# Access Compliance Report Public Rights-of-Way (Curb Ramps)

| Main Street: SIENNA_PKWY                |                                   | Cross Street: ZINNIA_ST |                                         | Location:       | NW |
| ADA ID: RPRK211111135437                | Ramp Type: Type 1 - Perpendicular | Initial Pass/Fail: Fail | Overall Compliance: No                  | Severity Score: | 15 |

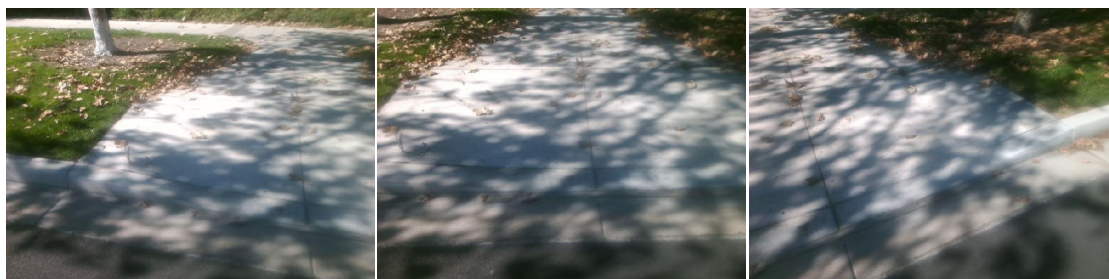
| Compliance | Description                           | Data | Compliance | Description                   | Data |
|------------|---------------------------------------|------|------------|-------------------------------|------|
| No         | Ramp Run Slope (%)                    | 10.4 | N/A        | Flare Slope LT (%)            | N/A  |
| N/A        | Gutter Ponding                        | N/A  | No         | Curb Slope                    | 17.4 |

**Remove & Replace Entire Ramp.**

**R304.2.2, R204.3, STD 1115**
